UNITED STATES PATENT AND TRADEMARK OFFICE

APPLICATION NO.	FILING DATE	FIRST NAMED INVENTOR	ATTORNEY DOCKET NO.	CONFIRMATION NO.
10/824,248	04/14/2004	Dragan Veskovic	LUTR-0241/03-055 P2	6423
23377	7590	12/13/2005	EXAMINER	
WOODCOCK WASHBURN LLP ONE LIBERTY PLACE, 46TH FLOOR 1650 MARKET STREET PHILADELPHIA, PA 19103			VO, TUYET THI	
			ART UNIT	PAPER NUMBER
			2821

Office Action Summary

DETAILED ACTION

FIG. 1

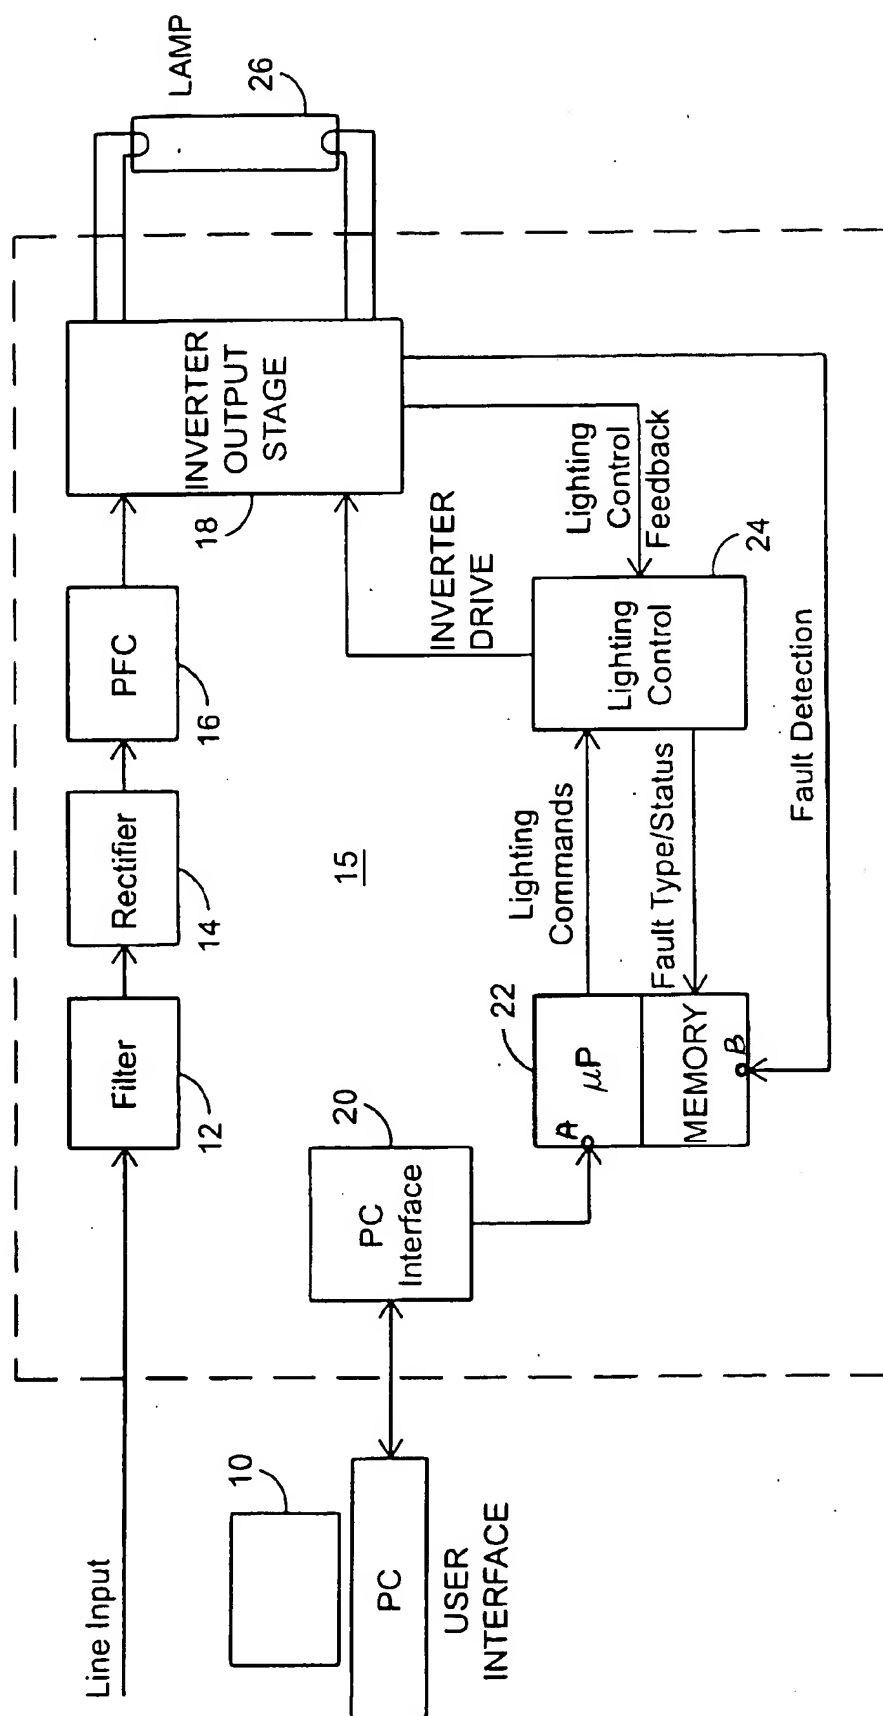
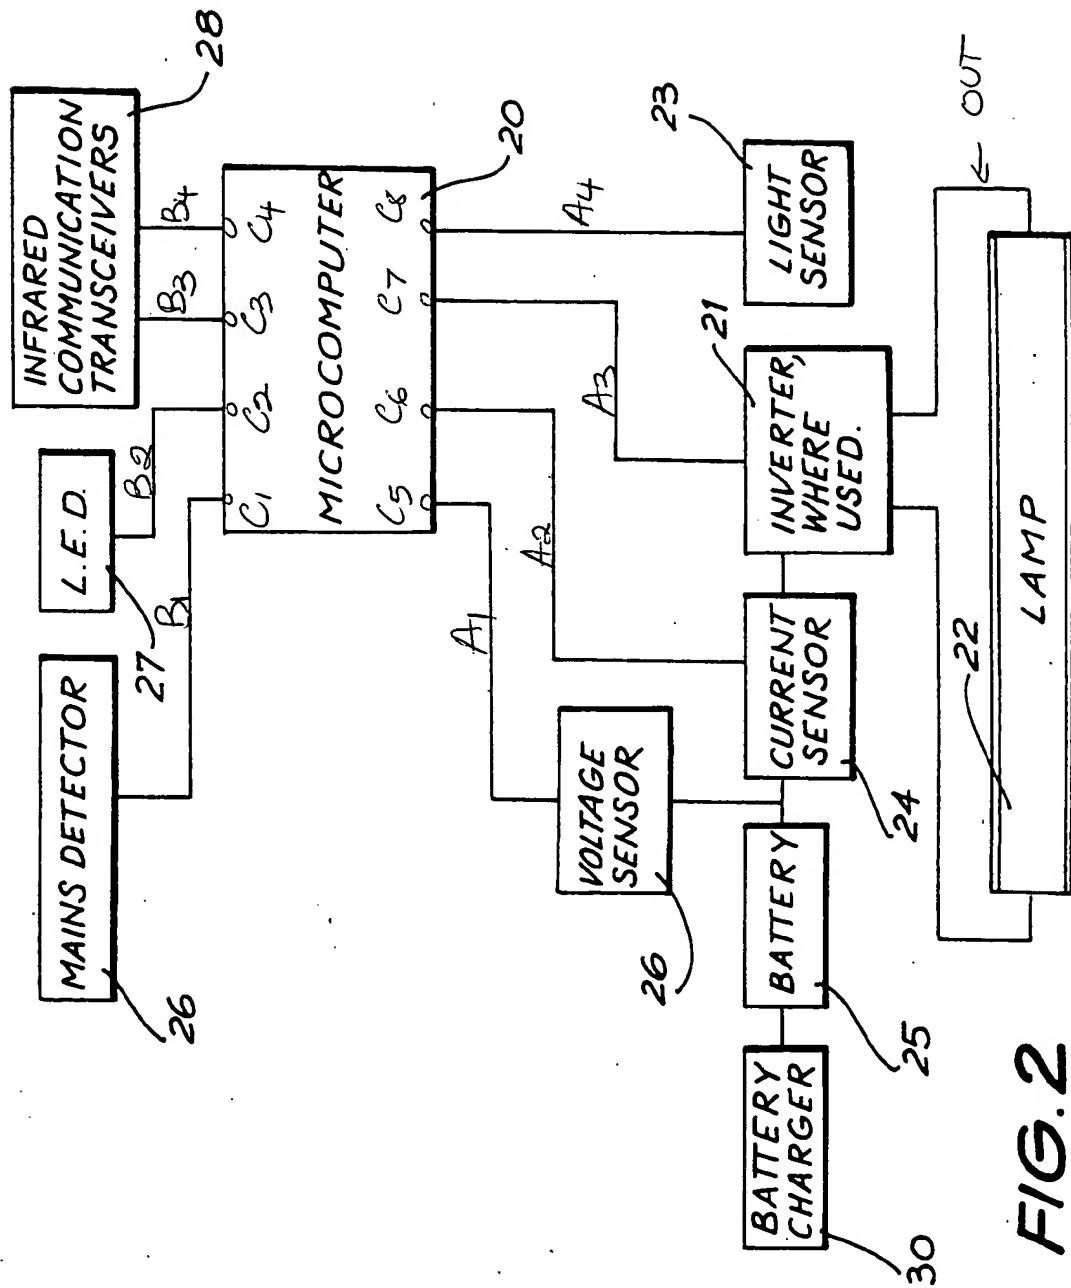
a microcomputer (20) for controlling a level of a ballast output signal (OUT, marked by examiner) for gas discharge lamp (22) in response to a plurality of ballast control signals (A1-A4, B1-B4, marked by examiner);

an inverter (21), inherently/conventional having at least one switch, for receiving a processor output signal (A3) from said microcomputer (20) and providing said ballast output signal (OUT) in response to said processor output signal (A3); and

a plurality of input terminals for receiving said plurality of ballast control signals (C1-C8, marked by examiner); wherein at least one of said plurality of input terminals (B3, B4) is a bidirectional terminal capable of receiving and sending control signals for communicating between the microcomputer and infrared communication transceiver (28).

Ribarich discloses an electronic ballast for driving a gas discharge lamp (Fig. 1), comprising

an inverter circuit (18, 24) producing a high frequency drive voltage for driving a lamp current in the gas discharge lamp;

a microprocessor (22) connected to said inverter circuit (18, 24); said microprocessor directly controlling said inverter to control said lamp current to a desired level;

ports (A, B, marked by examiner) connected to said microprocessor for receiving a message/command and providing said message/command to said microprocessor;

FIG. 4

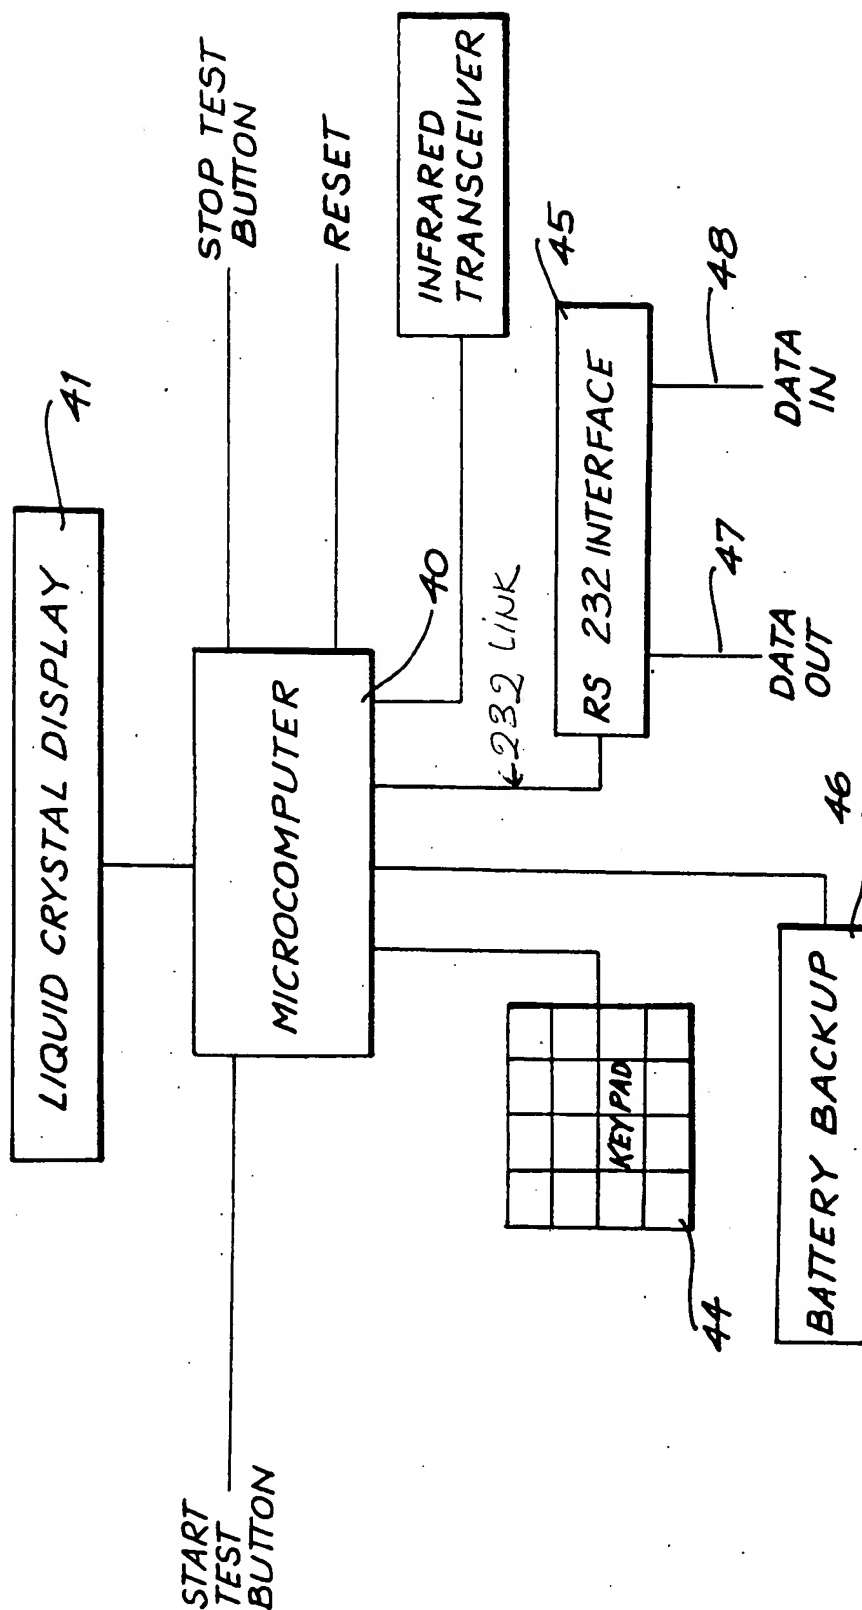
A port in electrical communications (45) with the microcomputer (Fig. 4) for sending message comprising at least one of command and ballast configuration (col. 8, lines 37-42), wherein the port (45) having one of receiving message (232-LINK, marked by examiner) and both receiving (47) and sending message (48). The microcomputer contains a program for responding to a message received via the port by sending a message via the port (Figs. 4 and 5).

at least one port (C1-C8) connected to said microprocessor for receiving a message and providing said message to said microprocessor, wherein a memory included in microprocessor; and a set of data stored in said memory for carry automatic self test, program test and other for controlling the lamp level in an emergency, said microprocessor being adapted to change a portion of said set of data in response to receiving a predetermined message via a Key pad or other sensing signals (voltage sensor, current sensor, light sensor, IR transceiver)
